# Access Compliance Report

## Public Rights-of-Way

### (Curb Ramps)

Intersection ID: 10036745	Main Street: S_GRAHAM_ST	Cross Street: N/A	Location: SW
ADA ID: 490F09C60F60	Ramp Type: BlendTrans1	Initial Pass/Fail: Fail	Overall Compliance: No
		Severity Score: 12.5

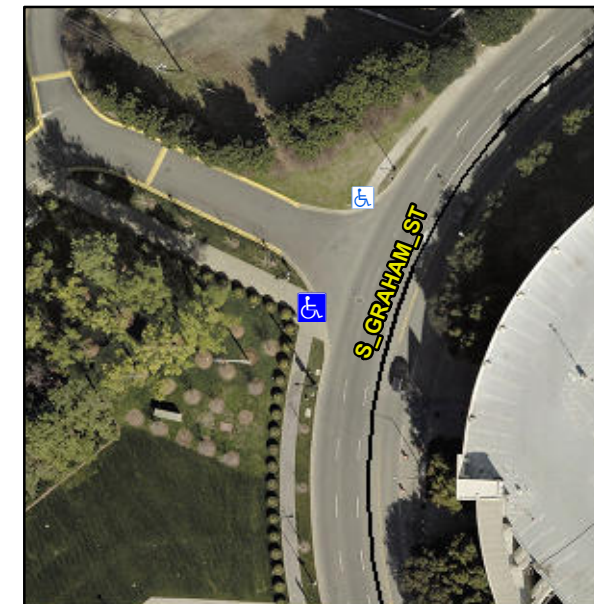
Compliance	Description	Data	Compliance	Description	Data
N/A	Ramp Length (in)	120.0	Yes	BlendTrans Slope (%)	0.0
Yes	Ramp Width (in)	89.0	No	BlendTrans XSlope (%)	5.8
N/A	Flare Type LT	N/A	N/A	Flare Type RT	N/A
N/A	Flare Slope LT (%)	N/A	N/A	Flare Slope RT (%)	N/A
N/A	Flare Traversable LT?	N/A	N/A	Flare Traversable RT?	N/A
N/A	Landing Length (in)	N/A	N/A	DWS Provided?	N/A
N/A	Landing Width (in)	N/A	N/A	DWS Contrast?	N/A
N/A	Landing Slope (%)	N/A	N/A	DWS Length (in)	N/A
N/A	Landing X Slope (%)	N/A	N/A	DWS Full Width?	N/A
N/A	Landing Curb? (Y/N)	N/A	N/A	DWS Offset (in)	N/A
N/A	Shared Landing?	N/A			
N/A	Gutter Ponding?	N/A	N/A	Gutter Slope (%)	N/A
N/A	Gutter Lip Ht (in)	N/A	N/A	Gutter X Slope (%)	N/A
N/A	Painted X Walk1?	No	N/A	Painted X Walk2?	No
	X Walk 1 Direction	To E		X Walk 2 Direction	To N
	X Walk 1 Width (in)	N/A		X Walk 2 Width (in)	N/A
	X Walk 1 Slope (%)	4.7		X Walk 2 Slope (%)	2.1
	X Walk 1 X Slope (%)	3.2		X Walk 2 X Slope (%)	1.2

**Remove & Replace Curb Ramp With Two New Directional Ramps or Equivalent.**

**R304.5.3**
